US Army Corps  
of Engineers  
Portland District

# PUBLIC NOTICE

Corps of Engineers Action ID: NWP-2005-587

**NOTE: Due to project modifications resulting in additional impacts to waters of the United States, the notice is being reissued for additional 15-day comment period. The changes are as follows:**

CUMULATIVE and AMENDED PROJECT ESTUARINE IMPACTS

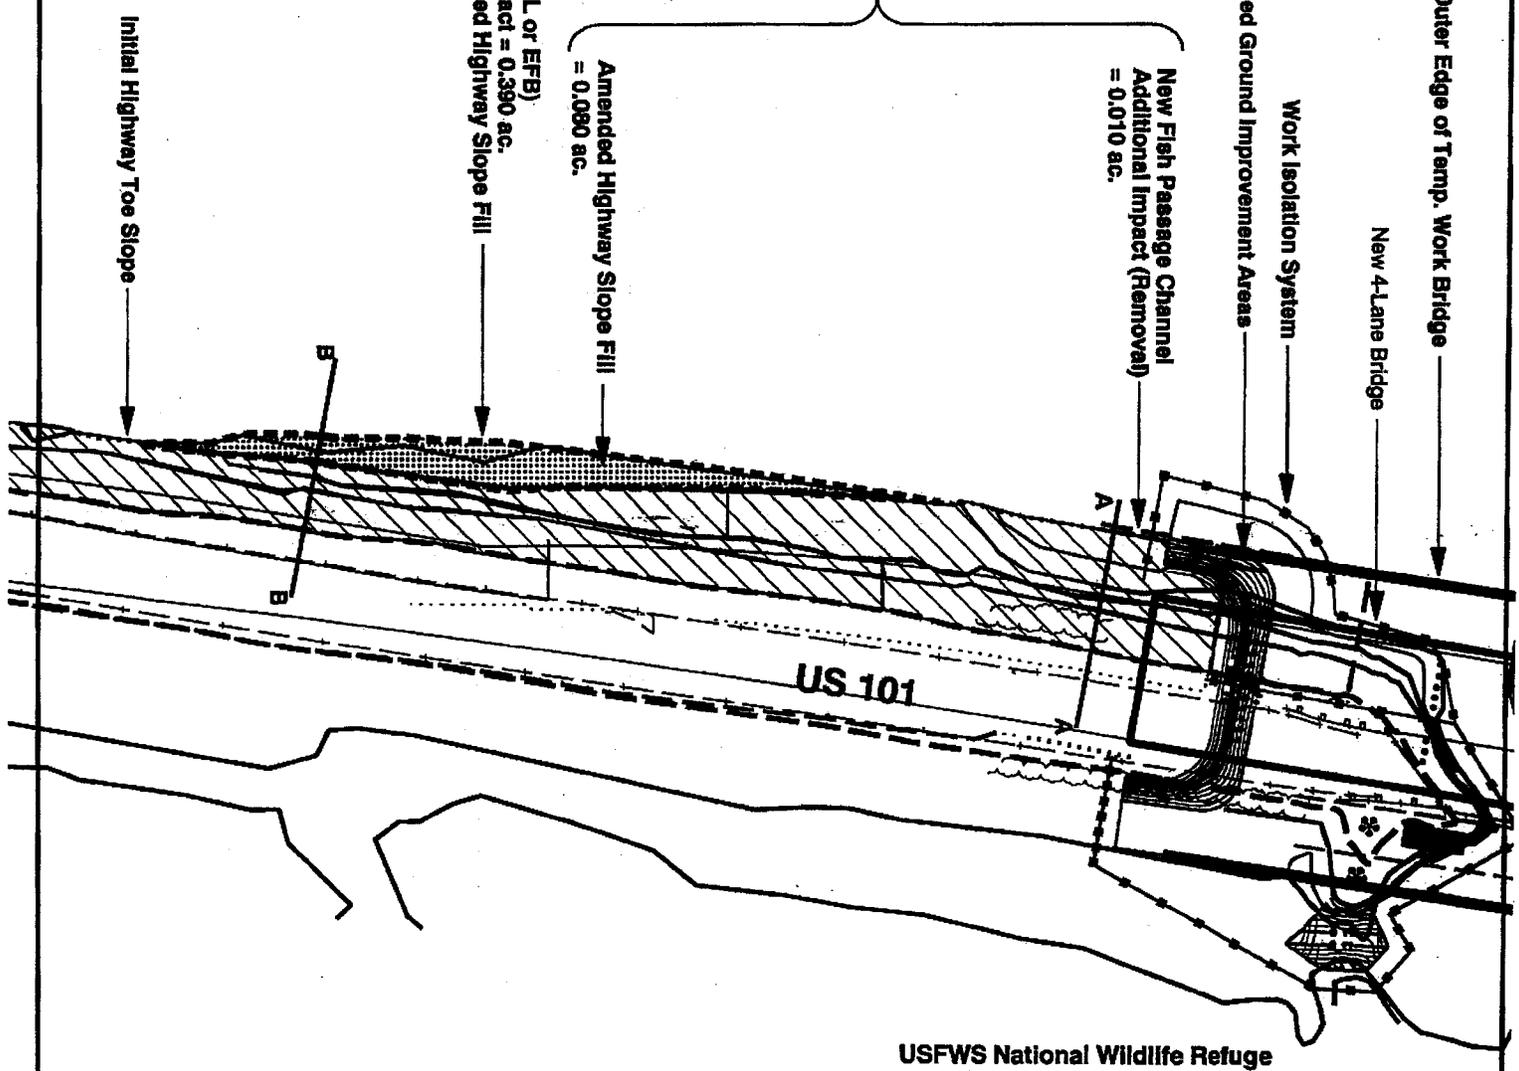
1. Oregon Department of Fish and Wildlife (ODFW) has advised the applicant that it is necessary to widen the side channel on the southern downstream side of the bridge to maintain hydrologic connectivity and ensure fish are not trapped at low tide. The new channel area will be converted from low salt marsh to mud flat and requires an additional 0.1 acre of fill within the Corps' jurisdiction.

4. To ensure that local traffic can safely travel between US101 and Immonen Road at the south end of the project, ODOT's roadway designer determined that it is necessary to widen a portion of the highway causeway south of the bridge on the west side. This change results in additional impact of 0.08 acre of fill in low salt march and 0.02 acre of additional fill in the subtidal channel.

New Fish Passage Channel  
Additional Impact (Removal)  
= 0.010 ac.

Low Salt Marsh (EZEM1N or EFB)  
Cumulative Direct Impact = 0.241 ac.  
PLUS 0.080 ac. of amended highway  
slope fill and 0.010 ac. of removal for the  
fish passage channel = 0.331 ac.

Amended Highway Slope Fill  
= 0.080 ac.

Subtidal Channel (E1UBL or EFB)  
Cumulative Direct Impact = 0.390 ac.  
PLUS 0.02 ac. of Amended Highway Slope Fill  
= 0.410 ac.

**OREGON DEPARTMENT OF TRANSPORTATION**  
**AMENDED SUBTIDAL & INTERTIDAL MUD FLAT**  
**MITIGATION AREA**  
**GRADING PLAN**  
 US 101 MILLPORT SLOUGH BRIDGE REPLACEMENT SEC.  
 RURAL LINCOLN COUNTY  
 NOV. 2008  
 FIGURE 15 (Amended)

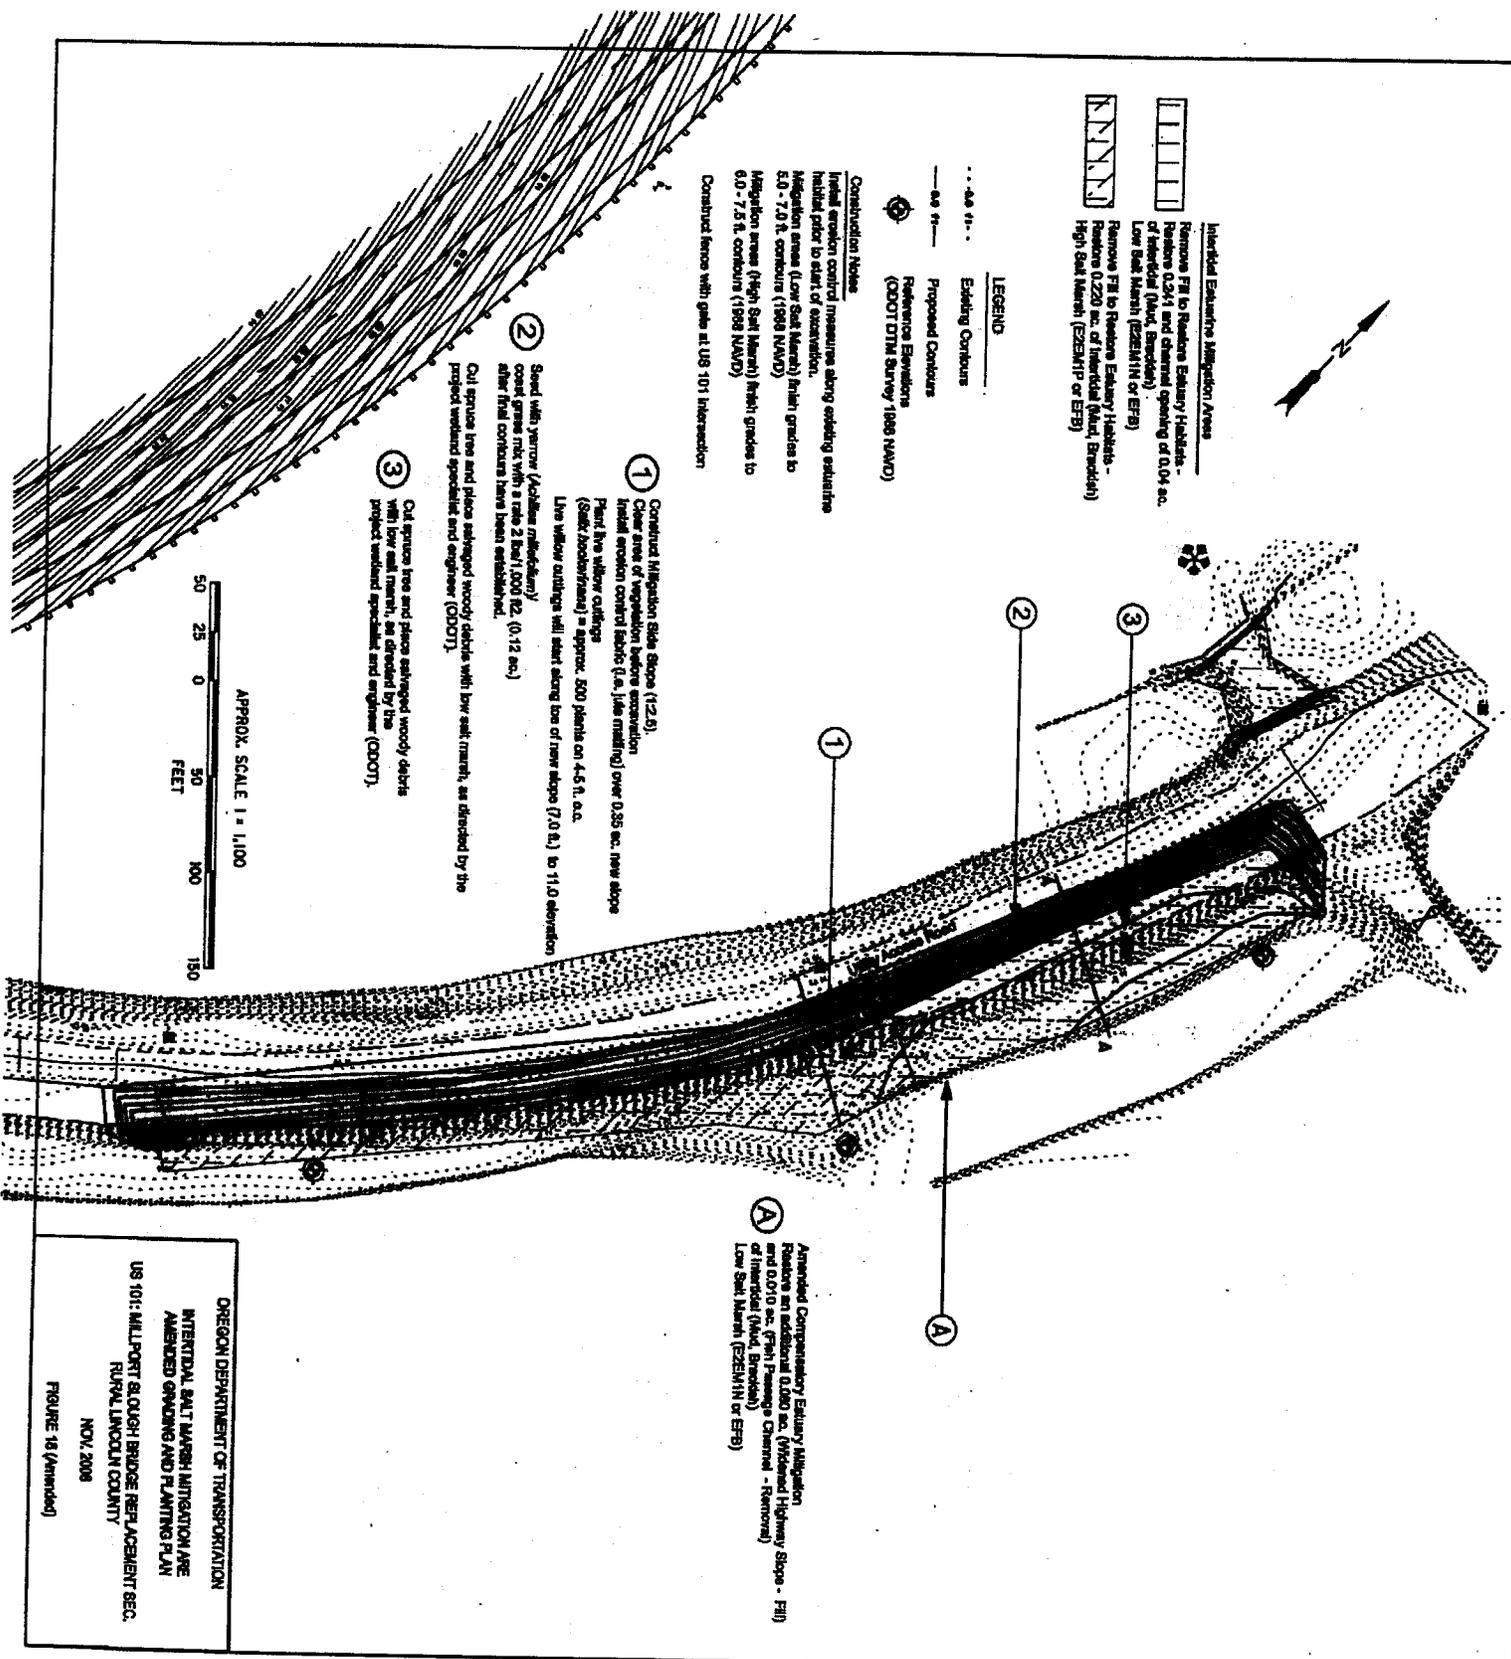
(A) Amended Highway Slope -  
 Additional Compensatory Mitigation of  
 0.020 acre (0.010 ac. each side) of  
 Subtidal and Intertidal (Mud, Brackett)

OREGON DEPARTMENT OF TRANSPORTATION  
 INTERMODAL SALT MARSH MITIGATION AND  
 AMENDED GRADING AND PLANTING PLAN  
 US 101 MILLPORT BLOUGH BRIDGE FERN ACQUIREMENT SEC.  
 RURAL LINCOLN COUNTY  
 NOV. 2008  
 FIGURE 16 (Amended)

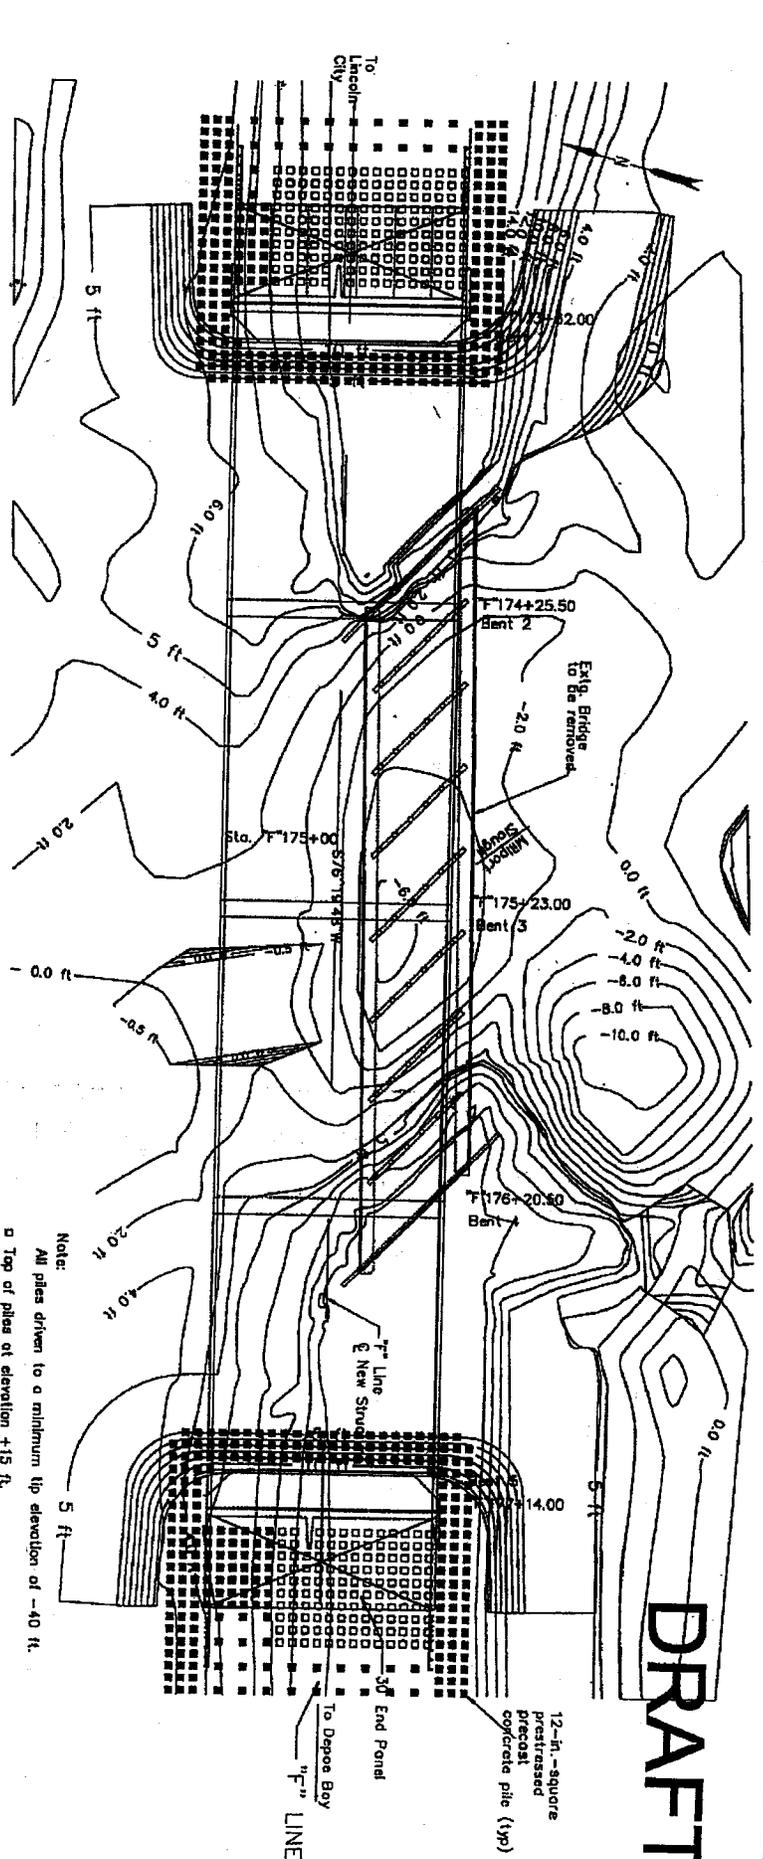
7. The above changes result in a modification to the applicant's mitigation plan for the proposed project. The proposed mitigation area for low salt marsh at the old U.S. 101 mitigation site has been enlarged by 0.08 acre, which is reflected in Figure 18 (see attached). No new mitigation is proposed for the 0.02 acre of subtidal channel fill as the mitigation originally proposed is still appropriate for the level of impacts.

**(A)** Amended Compensatory Estuary Mitigation. Restore an additional 0.083 ac. (Widened Highway Slope - Fill) and 0.010 ac. (Palm Fringe - Channel - Removal) of Intermodal (Mud, Breddick). Low Salt Marsh (E2EM1N or E7B)

FIGURE 19

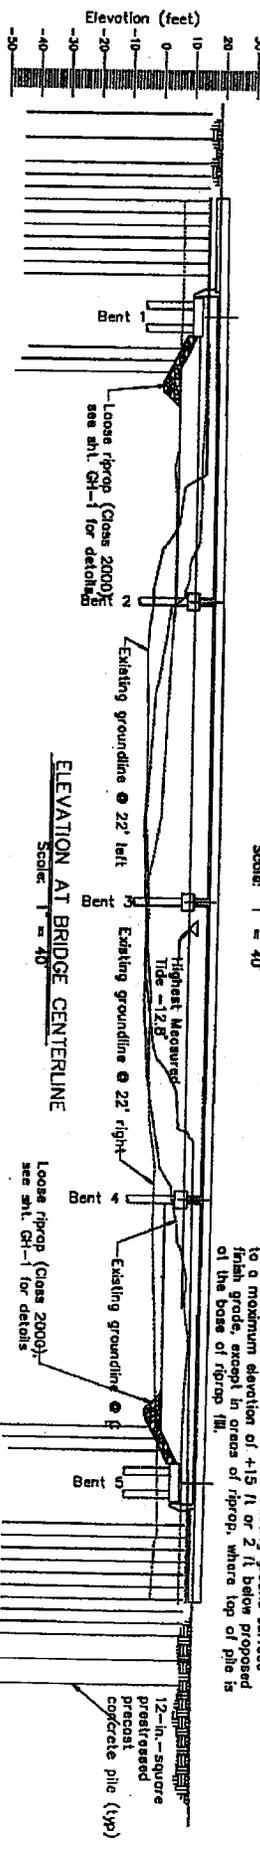
3. Additional geotechnical work has required the modification of the proposed piles. Instead of wood piles, the applicant is now proposing to use pre-cast concrete piles. This change results in a reduction in the volume and area of fill required.

- Note:
- All piles driven to a minimum tip elevation of -40 ft.
  - Top of piles at least 2 ft above existing ground surface to a minimum elevation of +15 ft or 2 ft below proposed finish grade, except in areas of riprap, where top of pile is at the base of riprap fill.
